Addendum No. 4

Date: April 15, 2013
To: Contractors
From: Matthias Mueller – Program Director
Reference: Bachelor Enlisted Quarters Facility
Utah National Guard – Camp Williams, Utah
DFCM Project No. 10281480

ADDENDUM FOUR

BACHELORS ENLISTED QUARTERS FACILITY

DRAWN BY	WRT	CHECKED BY	DLA
PROJECT NO.	11007	DRAWING NO.	EL103B
DATE	02/15/2013

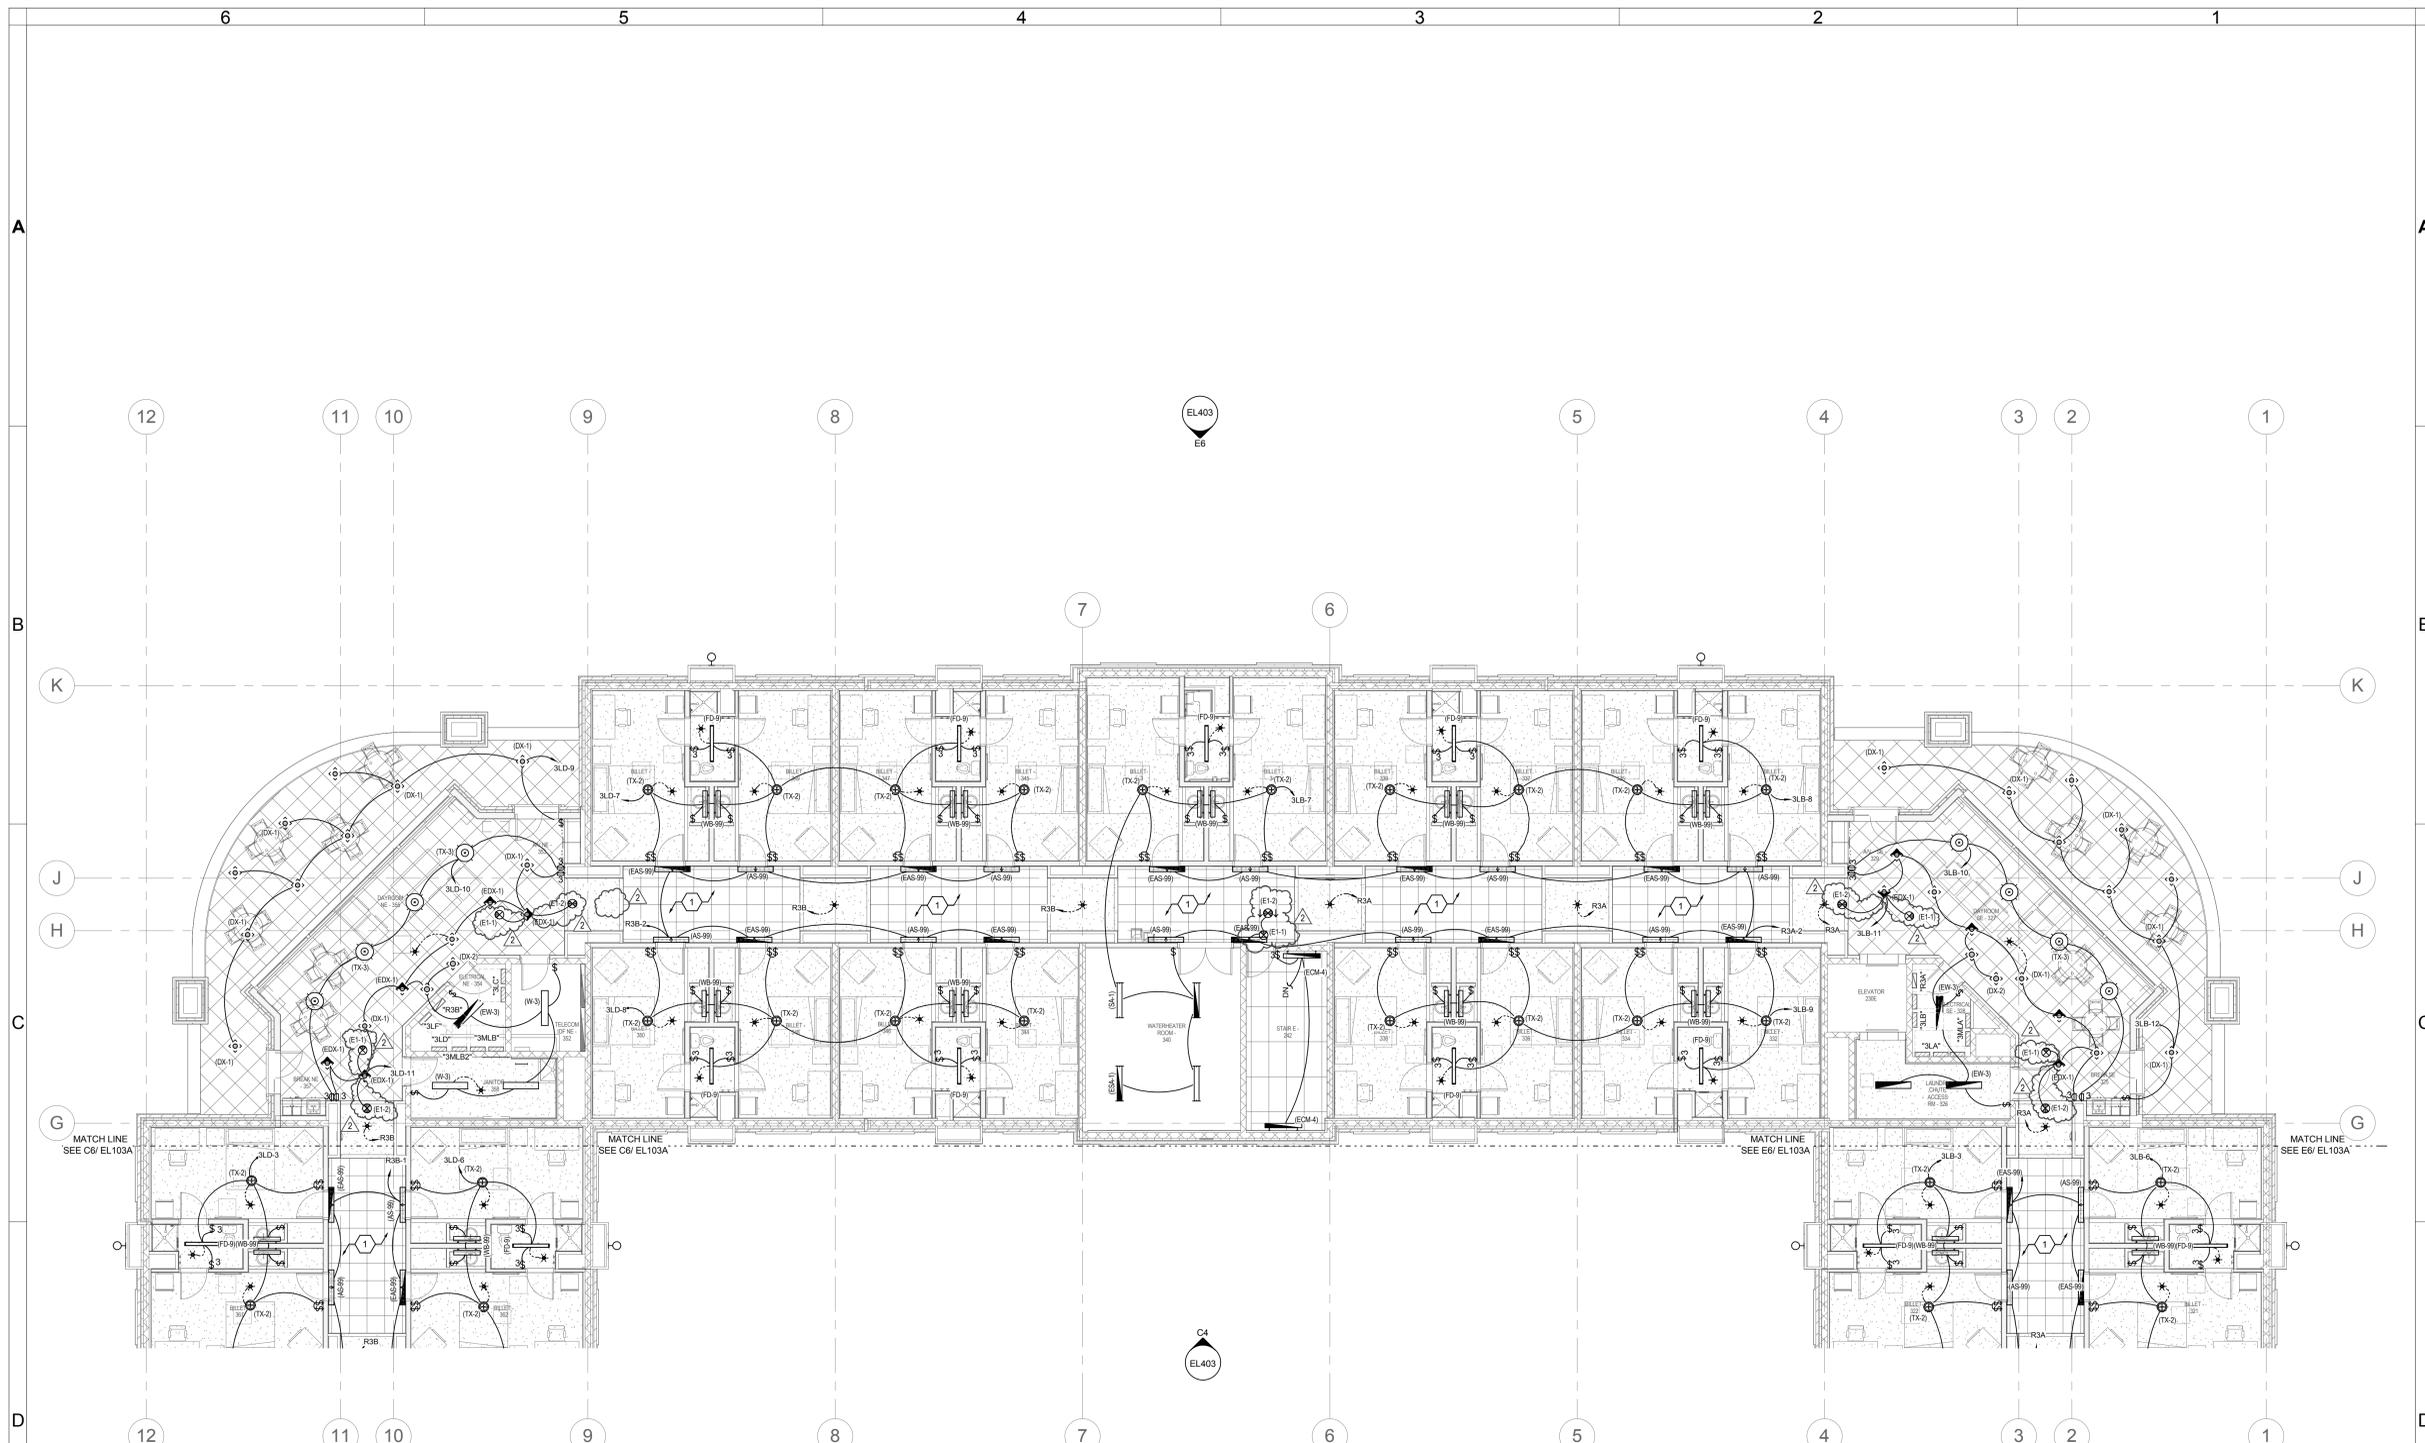
- 4.E08 Sheet EL103B – Sheet reissued with the following changes:
- a. Added (2) 2-sided exit signs in the corridors near Dayroom SE-327. Relocated (1) single sided exit signs in the adjoining corridor into Dayroom SE-327. Added (1) exit sign in Dayroom SE-327. Added power connections to the exit signs.

- b. Added (2) 2-sided exit signs in the corridors near Dayroom NE-355. Relocated (2) single sided exit signs in the adjoining corridors into Dayroom NE-355. Added power connections to the exit signs.

- c. Added (1) exit sign directly above the door to the middle stair. Added circuiting to the exit signs at the middle stair.
- 4.E09 Sheet FA101B – Sheet reissued with the following changes:

DRAWN BY	WRT	CHECKED BY	DLA
PROJECT NO.	11007	DRAWING NO.	FA101B
DATE	02/15/2013

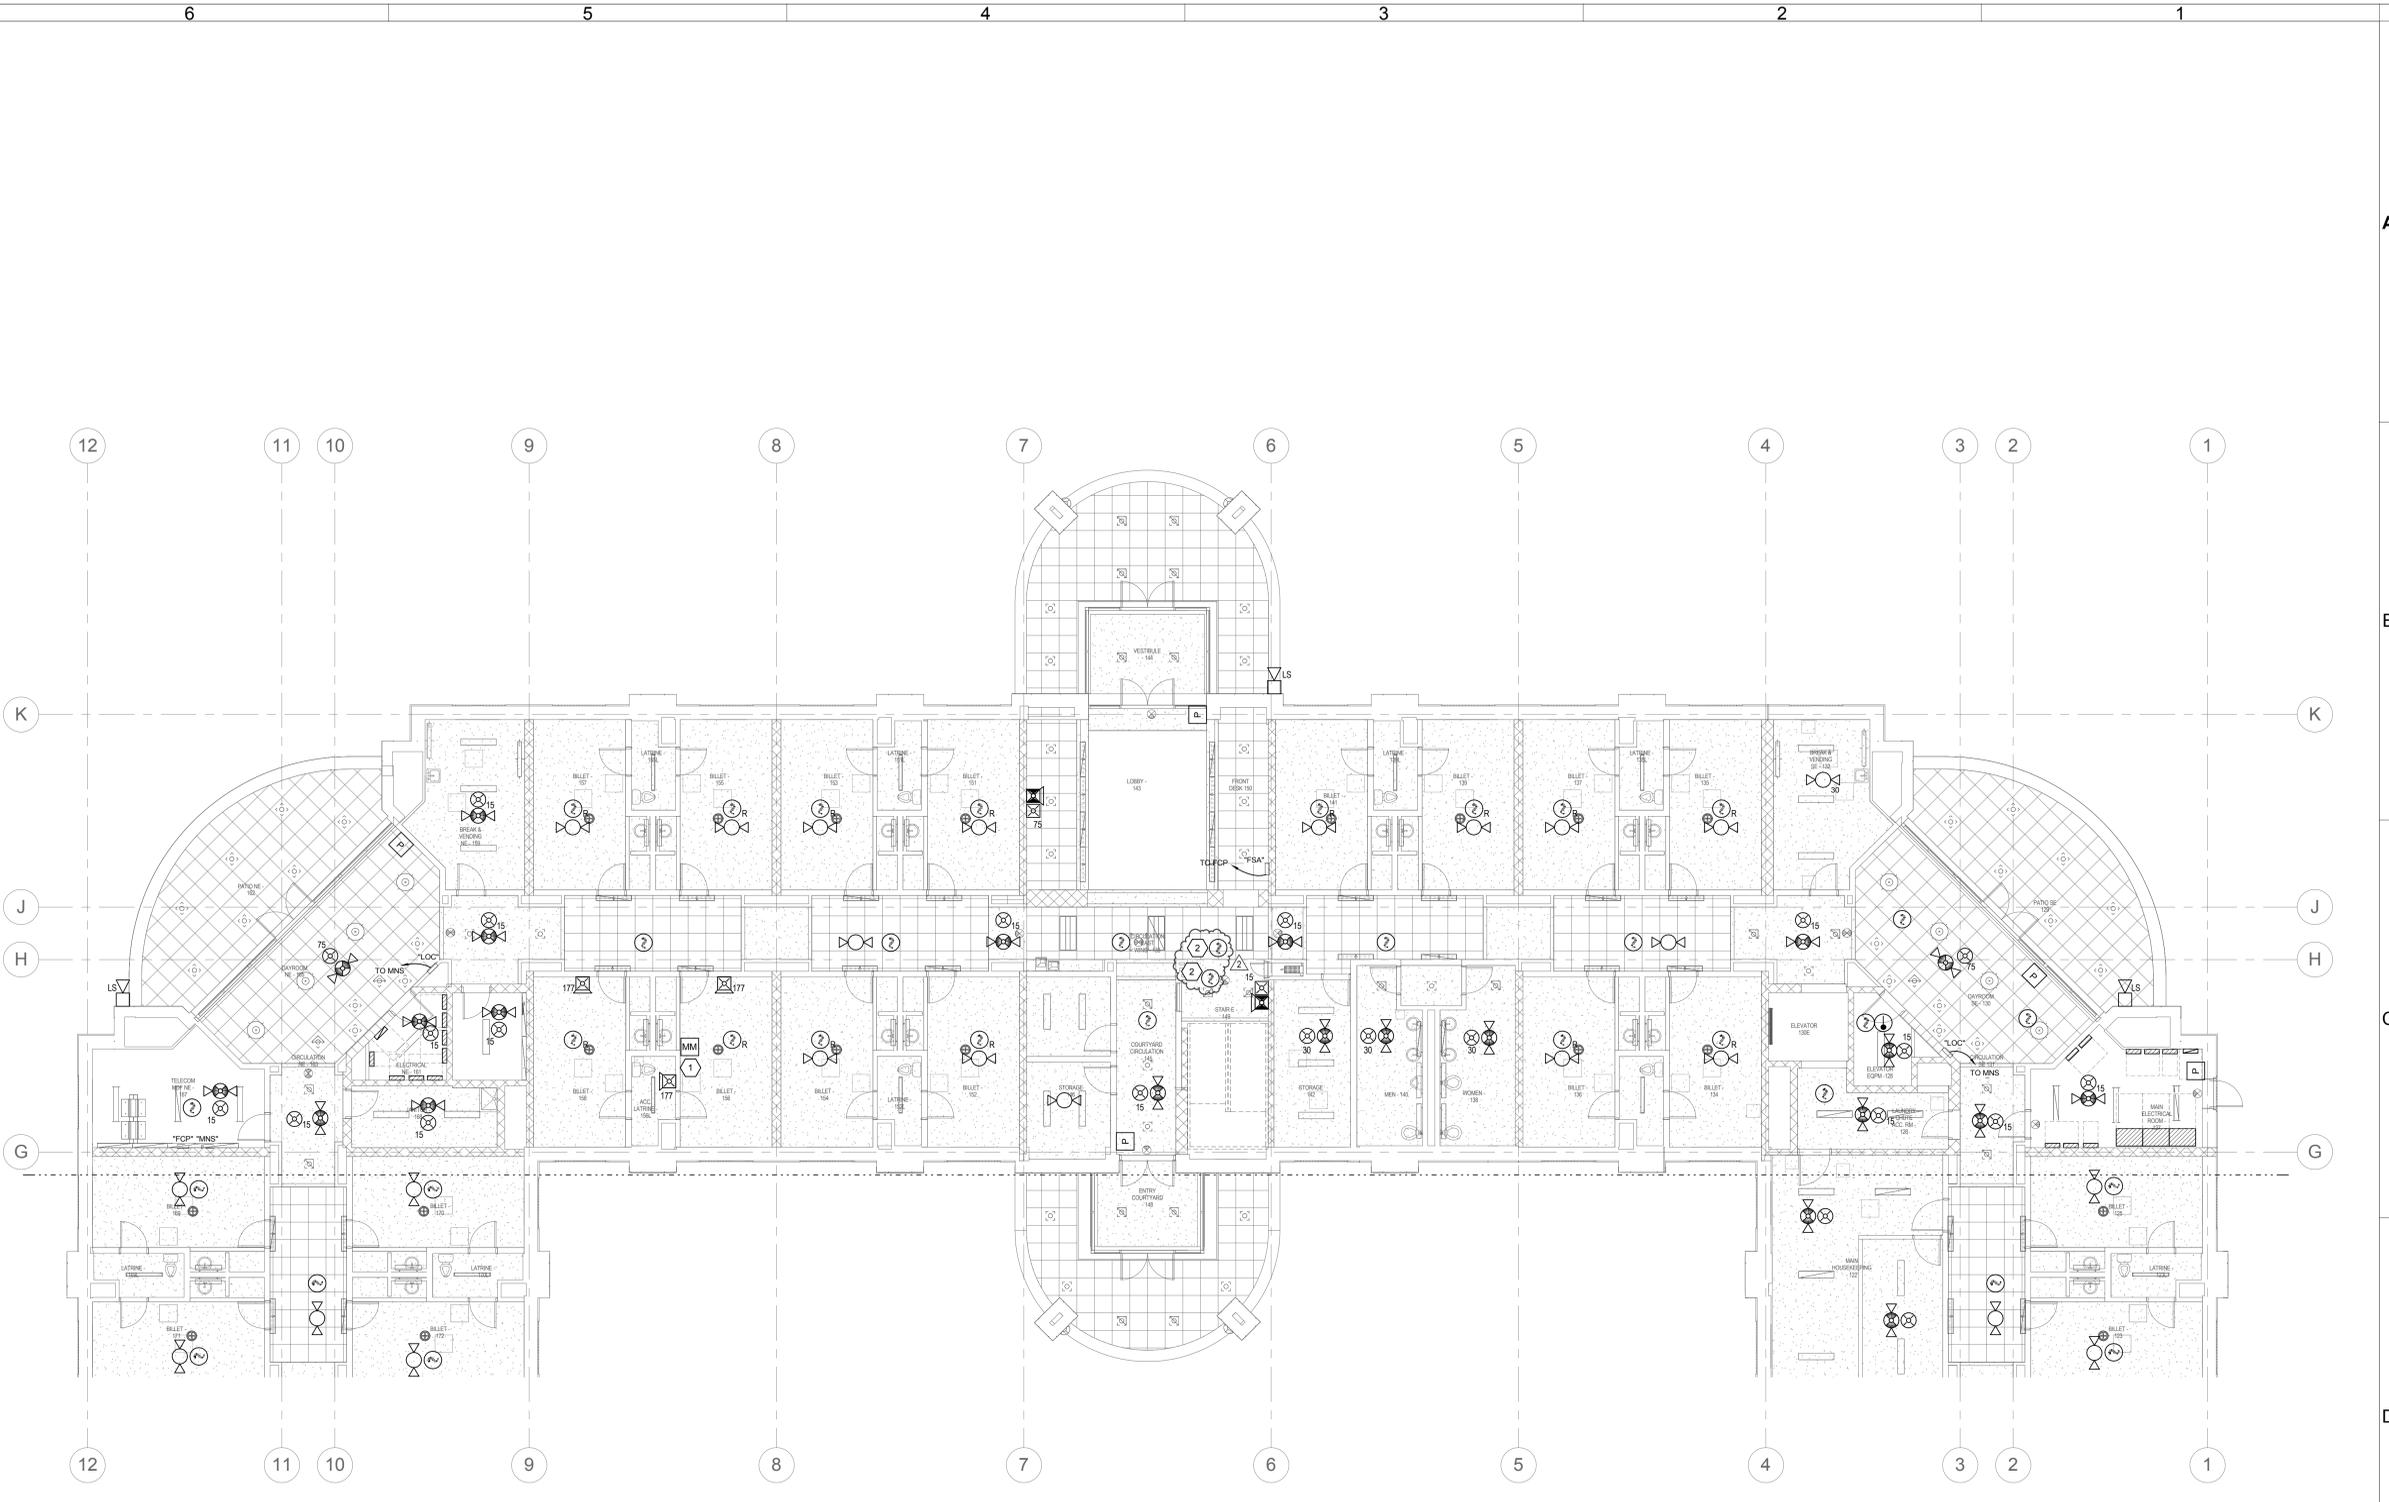
- a. Added (2) smoke detectors for operation of the fire door at the stairwell entry across from Lobby 143.
